Proposed ducting

From: Peter Bell <Peter.Bell@assetheritage.co.uk>
Sent: 26 July 2018 09:31
To: Richard
Subject: RE: WCDY - KX - 2018/2441/P following yesterday's site meeting re DUCT with Harts Group + Argent
Attachments: 20180725_114553.jpg

Casa Pastor Kings Cross

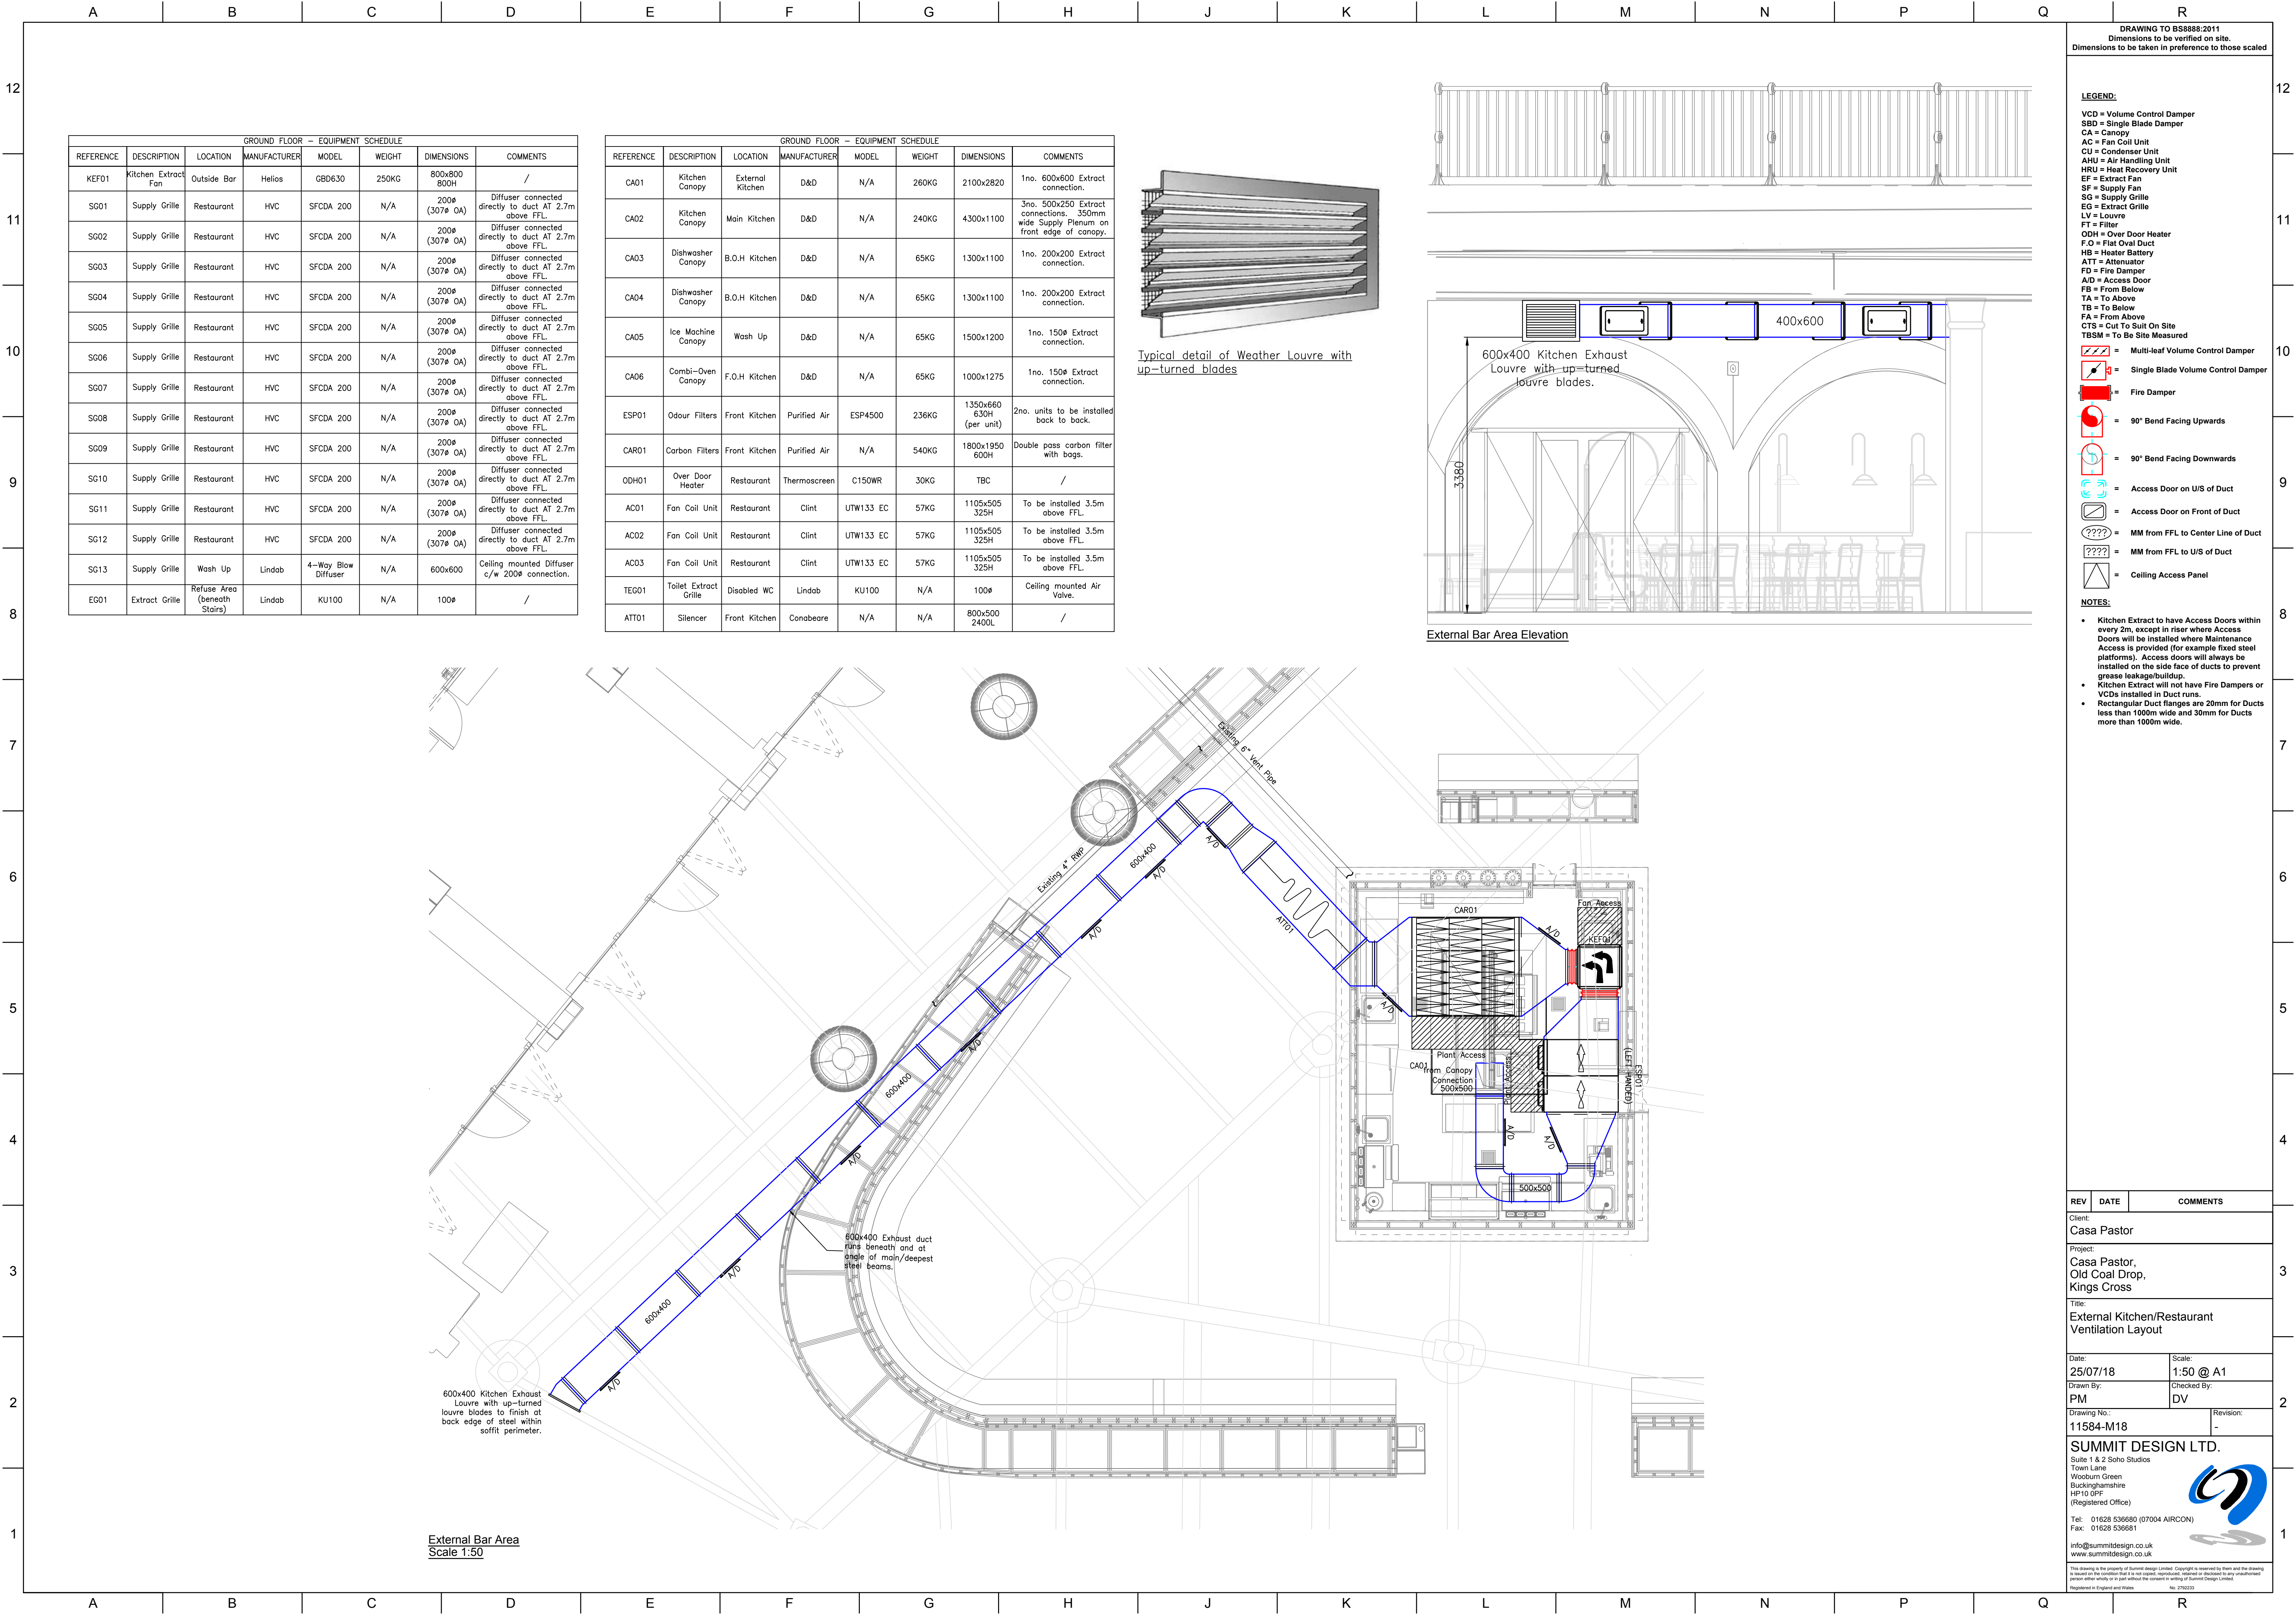
Alternative routes (vertical through the viaduct and to the rear/west) were discussed but were quickly ruled out. All were in agreement that the current proposal to run the duct under the viaduct and exit to the east was the most acceptable solution but the precise location for the duct in relation to the primary and secondary steel beams and the exhaust point were discussed at some considerable length.

It was eventually agreed (led by Alfie Stroud) that the most appropriate location for the duct was to run parallel to the southernmost beam as this location was already most affected by conduit and drainage pipes slung from the underside of the viaduct. It also left the second row of historic cast iron columns unencumbered. The duct outlet is to be black in colour and set back slightly from the edge of the viaduct so that it sits appears in its shadow line. My photograph of the 'mock-up' duct in this position is attached.

All agreed that this was the least visually noticeable location and that the heritage impact was very small and necessary for the functioning of the kitchen.

The agreed arrangement is now illustrated on drawing 11584-M18 by Summit Design Ltd.
